**IFB ADDENDUM # 1**

**IFB No. 18-004-19**

**Material and/or Service: General Contractor Services: Construction and Installation of an Outdoor Walk-In Freezer (49'8" x 17'8") for the Vail Unified School District, located at Empire High School 10701 E Mary Ann Cleveland Way, Tucson, AZ 85747**

**ADDENDUM NO: #1**

**R-1**

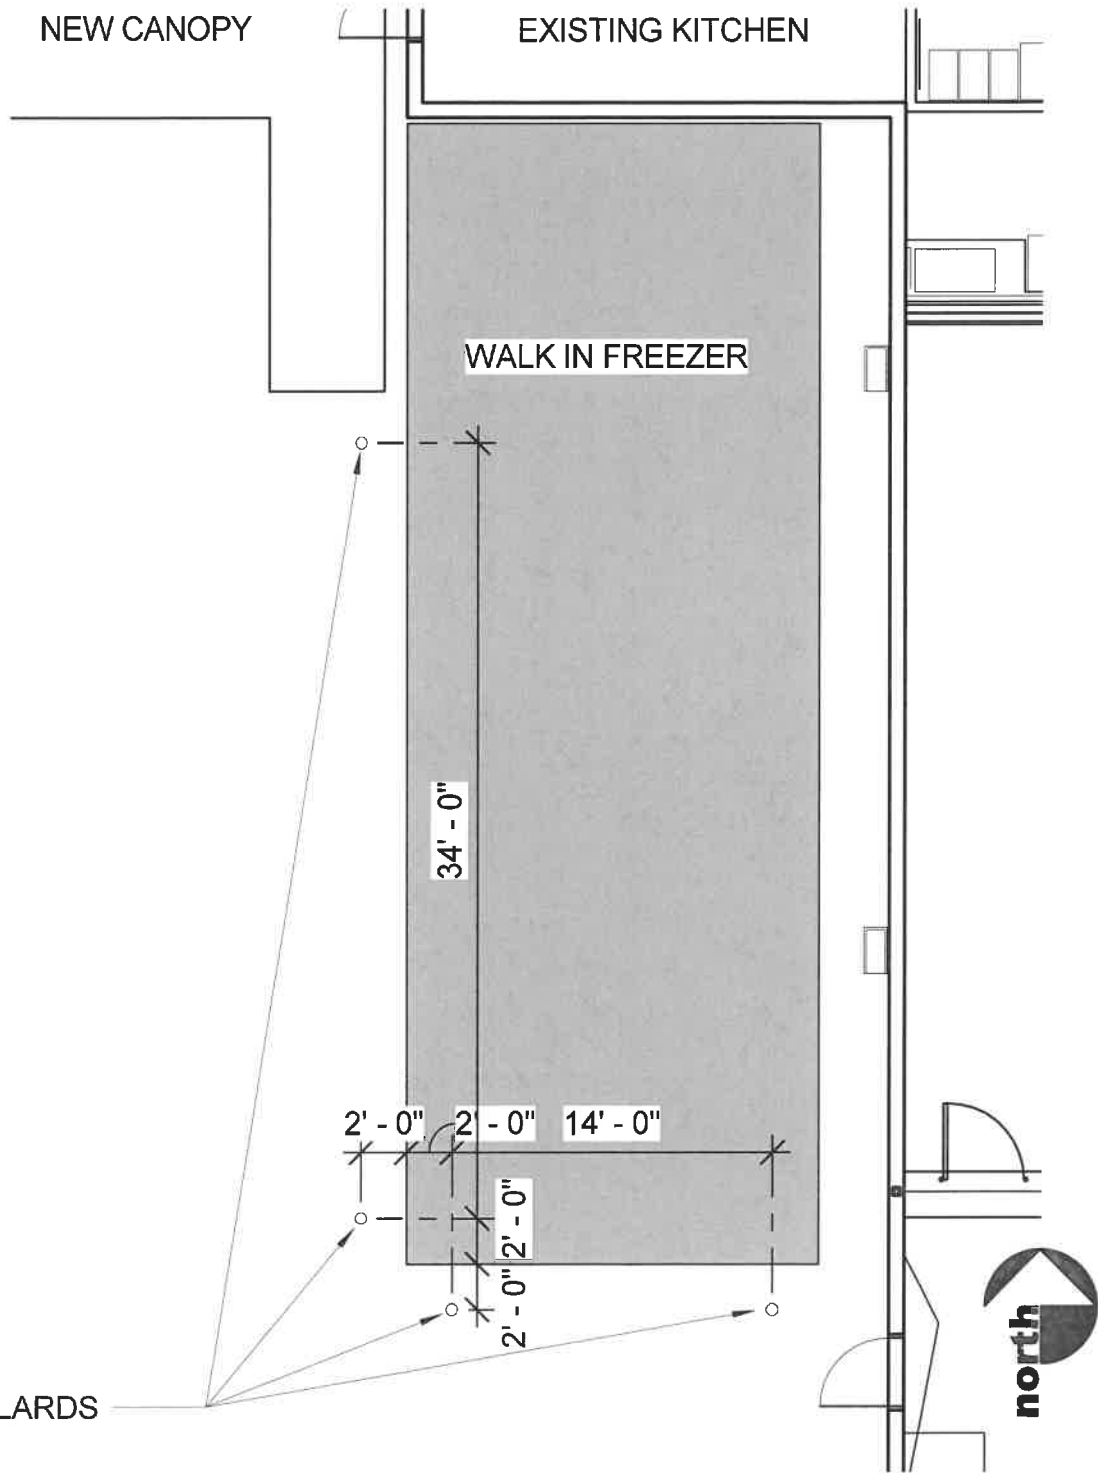
- ITEM 1:** Furnish and install steel pipe bollards per attached drawings R-1 and R-2.
- ITEM 2:** It is acceptable for the condensate water to drain directly on the asphalt pavement.
- ITEM 3:** Sheet FS 5.0, Insulated Slab Detail, increase the height of the sleeper and/or the concrete curb as required to maintain a level floor slab. The 6" dimension from the floor to the existing asphalt is a minimum.
- ITEM 4:** The freezer will need to maintain a standard temperature of -10°F.
- ITEM 5:** The minimum interior height inside the freezer is 7'-10 5/8".
